LES-13-00082-NRC

Louisiana Energy Services, LLC  
NRC Docket Number: 70-3103

Subject: Response to NRC Request for Additional Information on License  
Amendment Request (LAR) 12-10 Capacity Expansion of UUSA Facility  
(TAC L34193)

Figure 4.12-3 UBC Storage Pad Annual Dose Equivalent Isopleths (2,000 Hours per Year Occupancy)

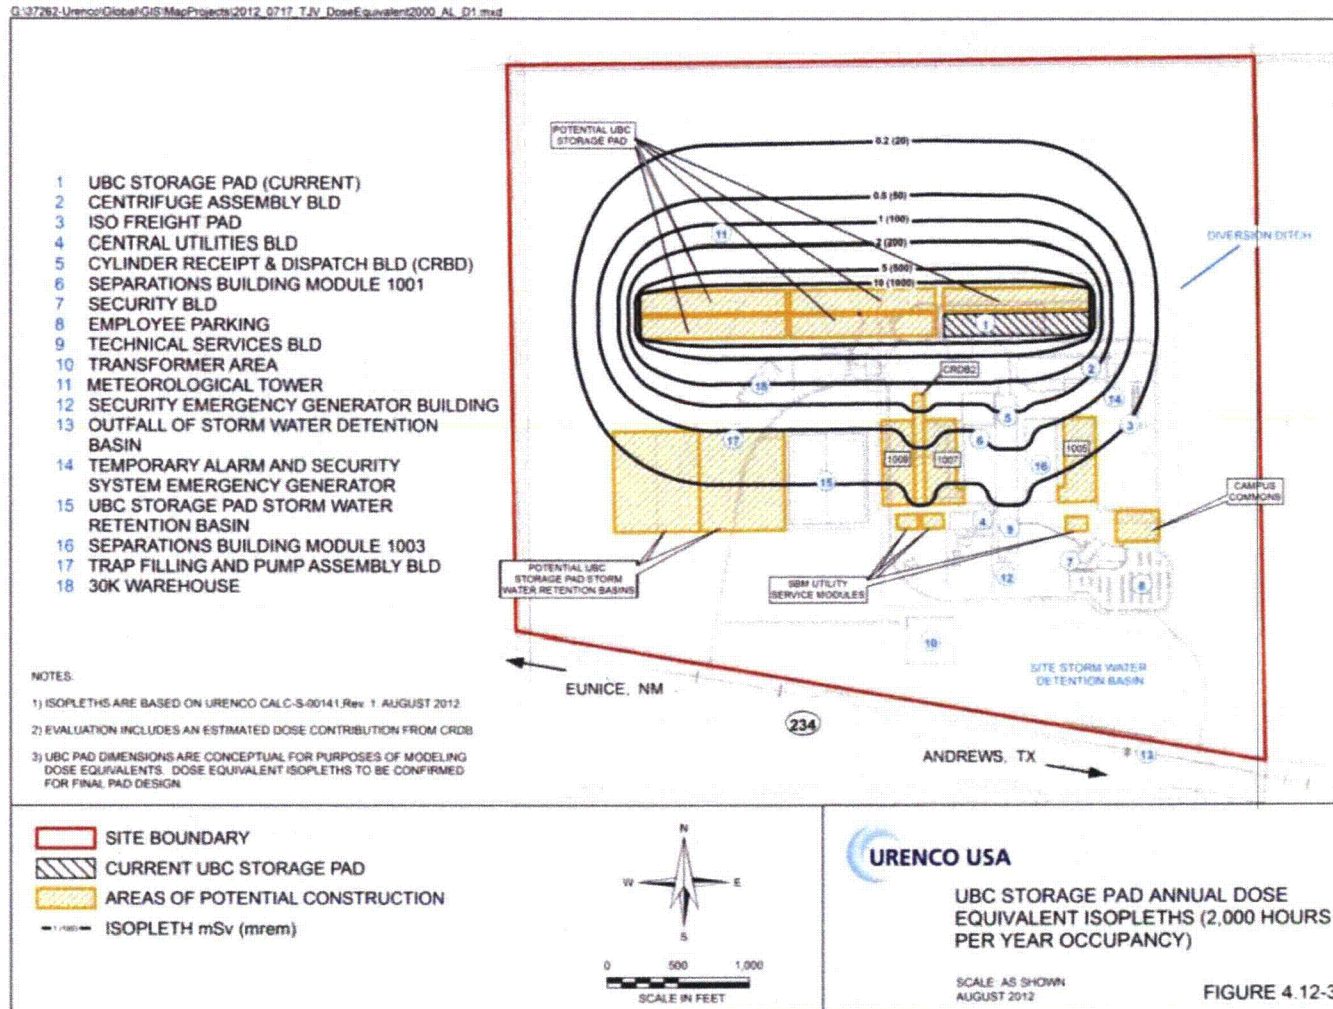
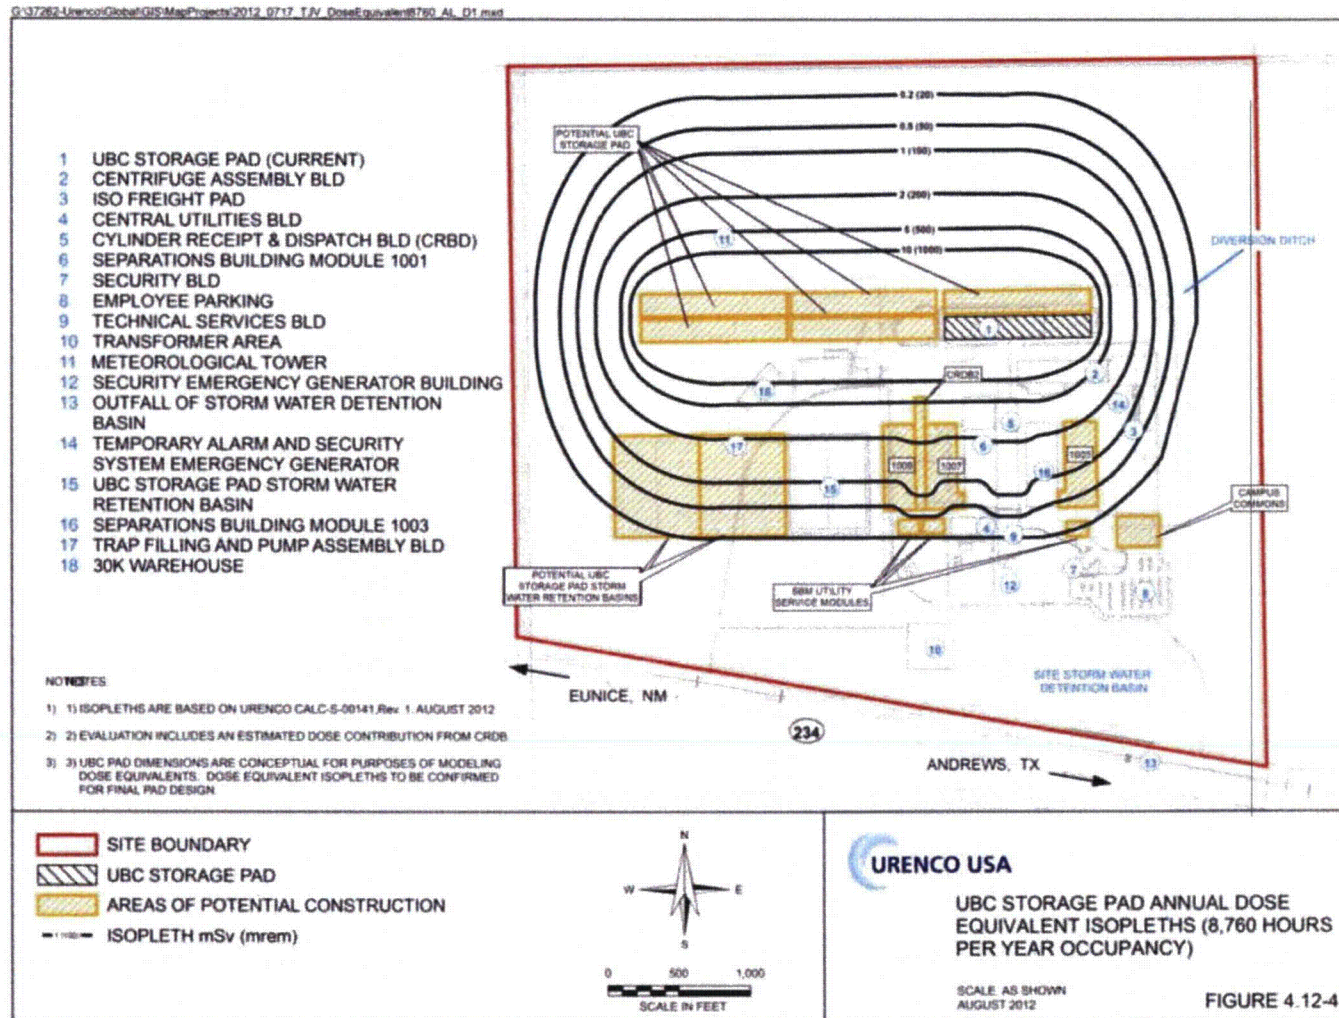
**RAI 4: Provide additional information on expected external dose rate estimates from the UBC Storage Pad.**

1. Table 4.1-2 lists a dose rate of < 0.01 mrem/hr for the plant general area excluding the separations building modules. Provide estimated dose rates in occupied areas close to the expanded uranium byproduct storage pad and describe the considerations given to these dose rates in the assessment of expanded facility operations.

UUSA is currently awaiting revised analytical data to support calculations to support this response. UUSA received verbal acknowledgement from the NRC Project Manager that the response is expected to be completed no later than July 31, 2013.
